# HD Engineering & Design

Permit No: PRRES20241195  
Plan Name:  
Project Address: 4359 NE HIDEAWAY DR, LEES SUMMIT, MO 64064  
Parcel Number: 284206

Our firm has been asked to make structural clarifications to the plans of the house to be built at the address listed above. During the permit review process the AHJ has questioned items. Below is a list of our recommendations along with the corresponding city item.

MCGRRAW HOMES  
Plan 2025, Lot 383, Park Ridge  
4359 NE Hideaway Dr., Lee's Summit, MO

**5**

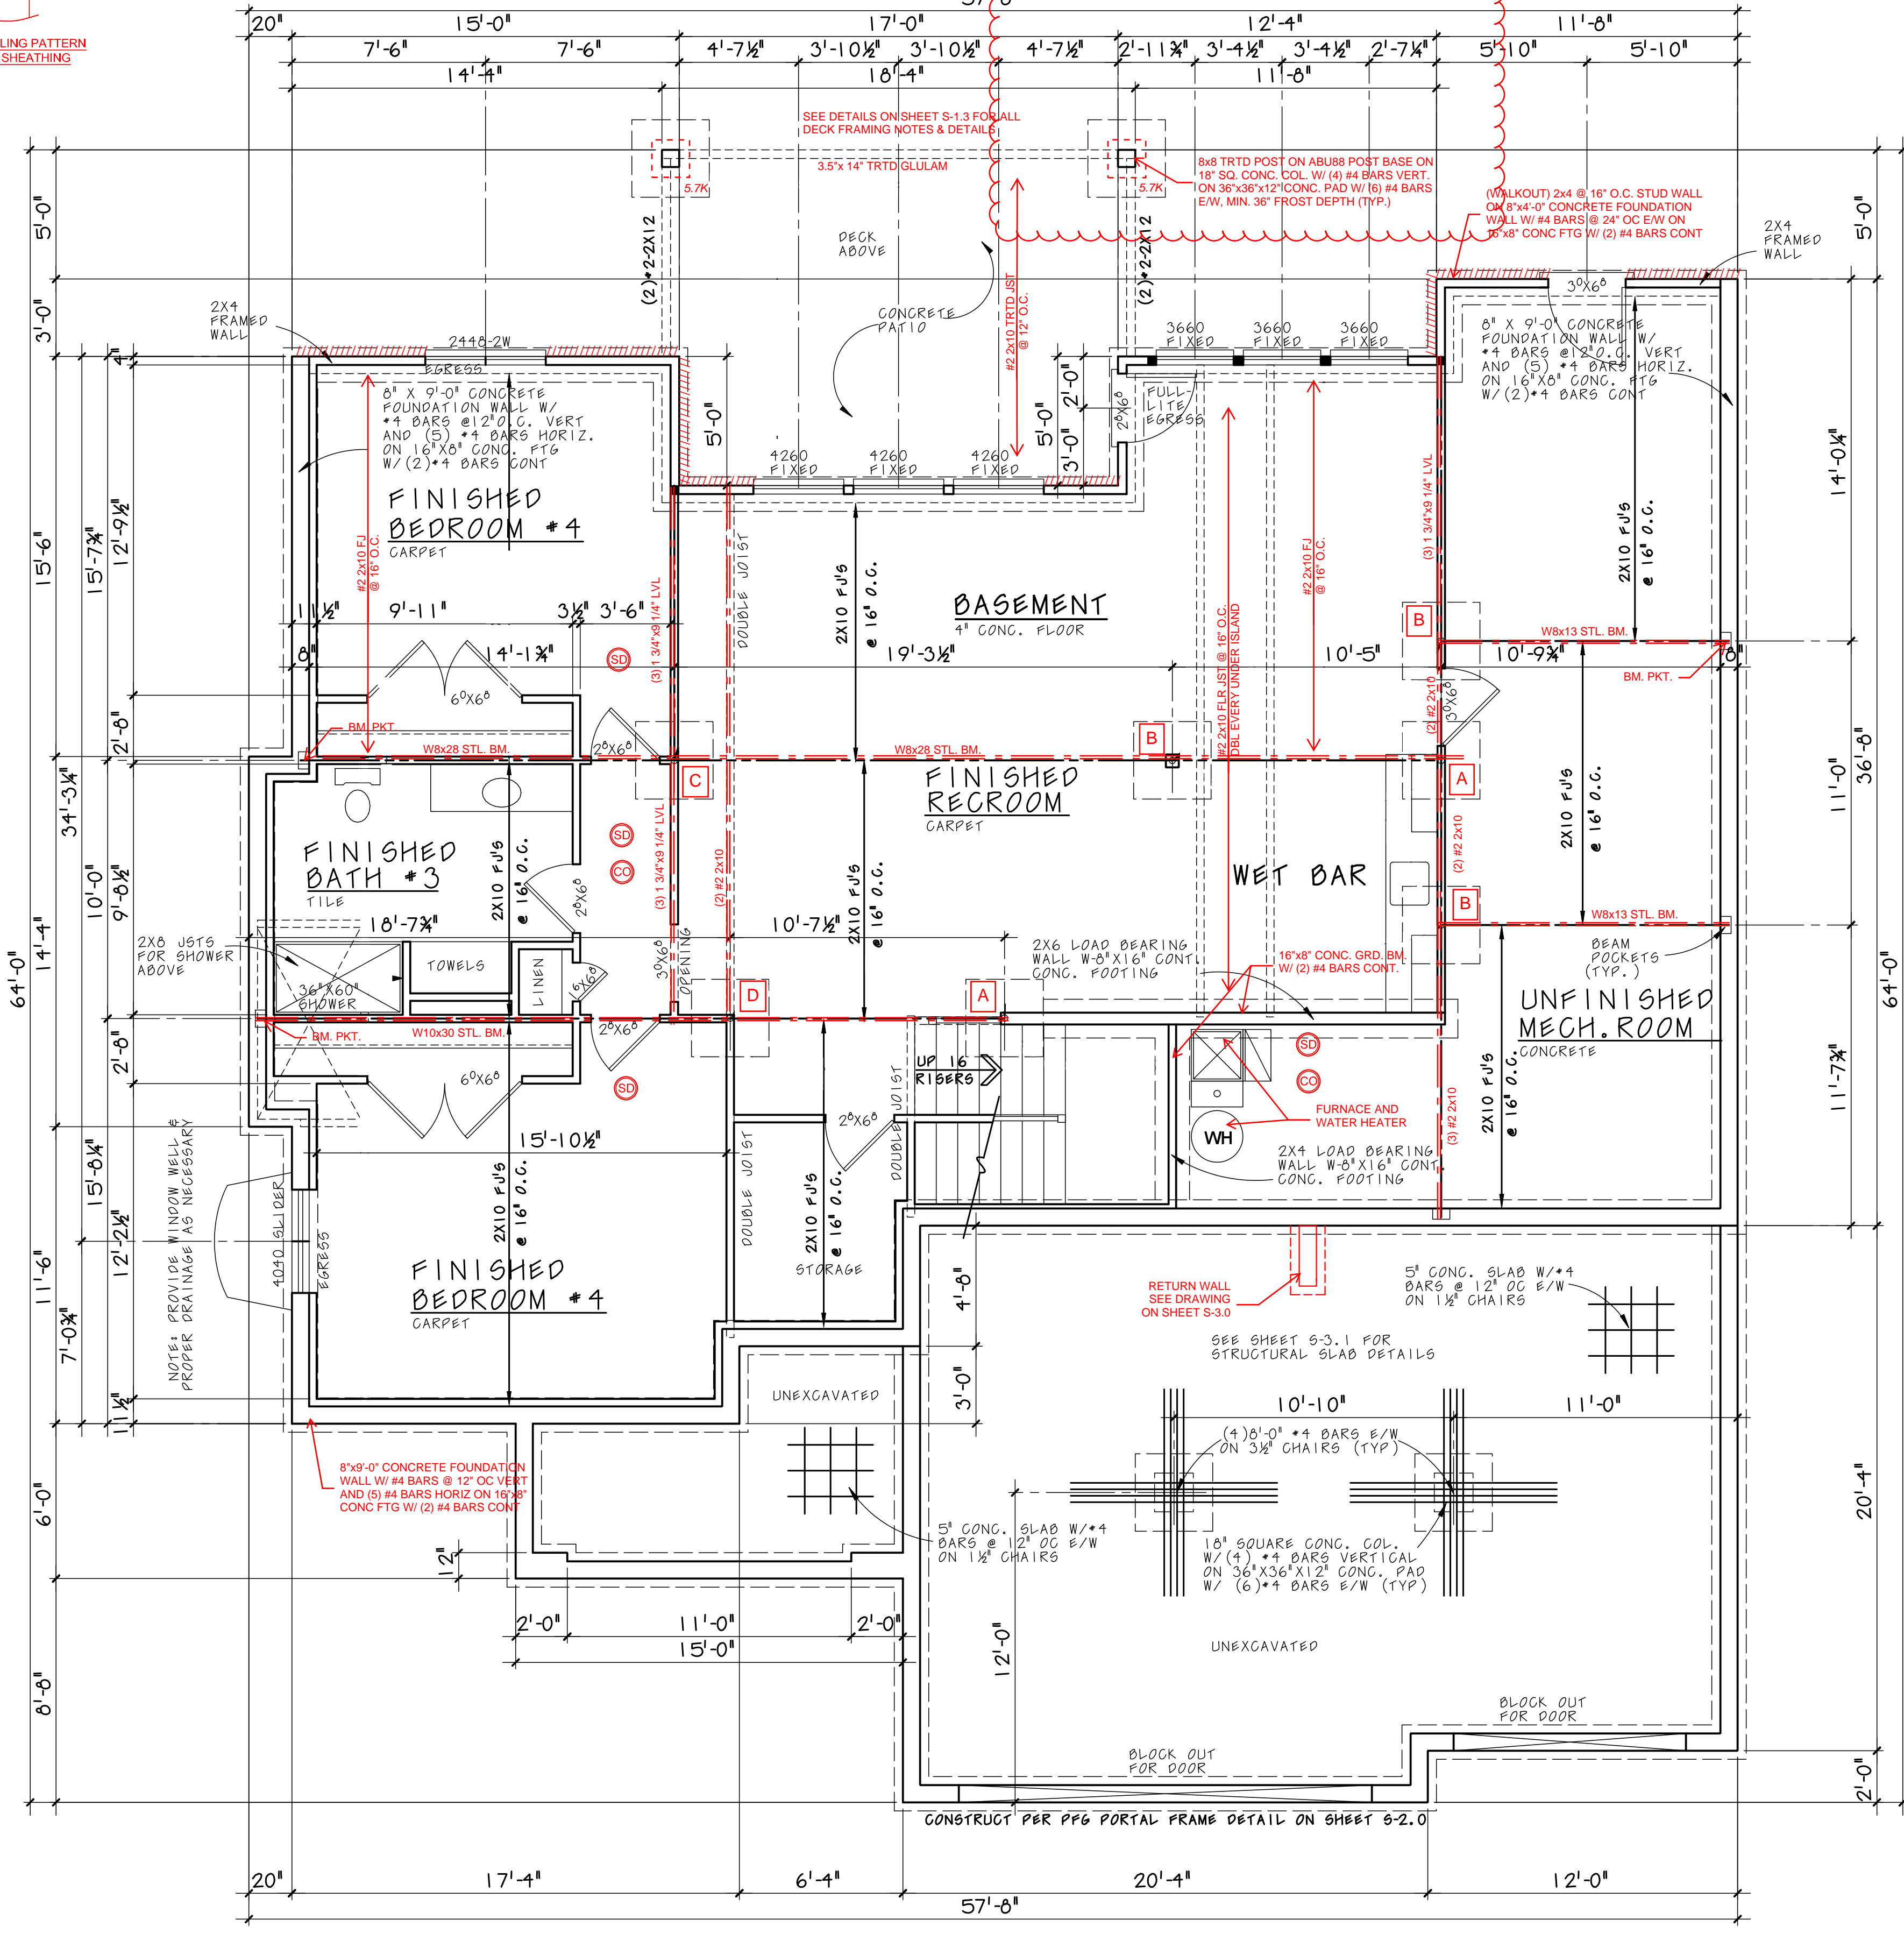
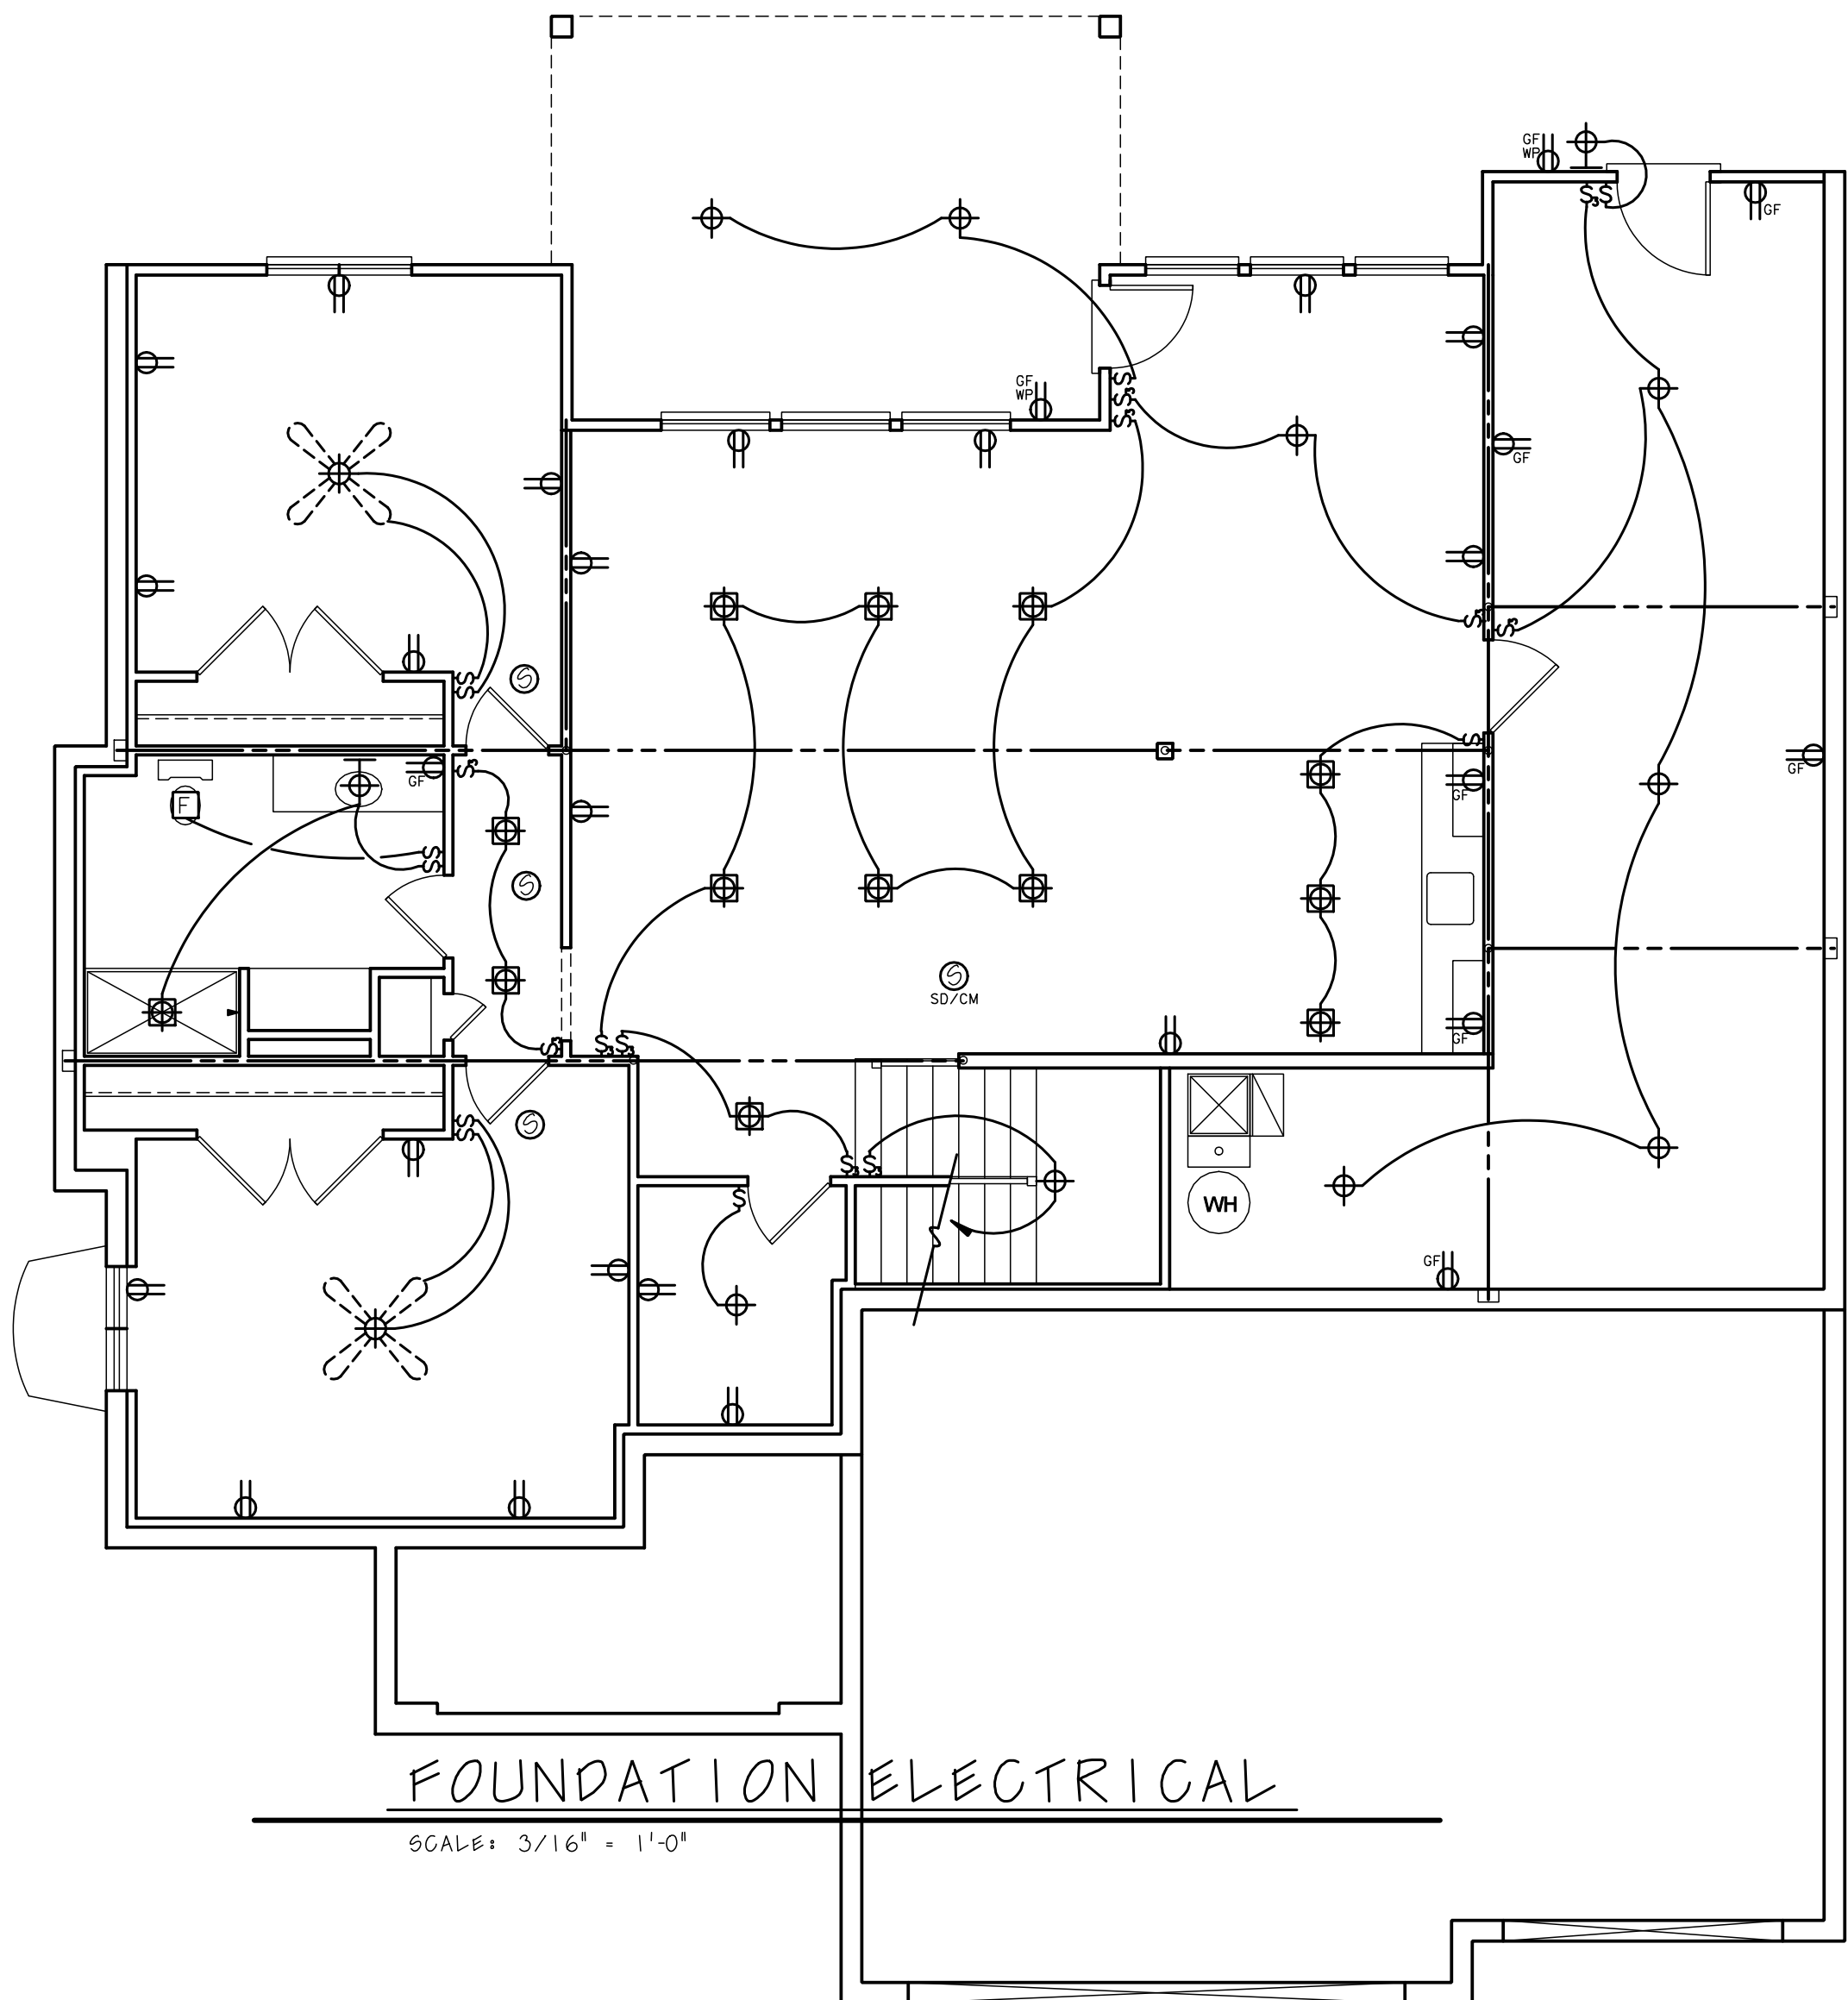
1. Provide combustion air calculations and specify transfer air grilles for fuel burning appliances located in confined space(s). (IRC Chapter 17 and Section G2407) **SEE CALCULATION ON S-1.3**
2. Footings, column pads, piers and grade beams - dimensions. (IRC Section R403) DECK PIER DETAIL NOT FOUND, SHOWS 12" DEEP PIER **SEE DETAIL AND NOTE ON SHEET 5**
3. Footings, column pads, piers and grade beams - reinforcement size and spacing. DECK PIER DETAIL NOT FOUND, SHOWS 12" DEEP PIER **SEE DETAIL AND NOTE ON SHEET 5**
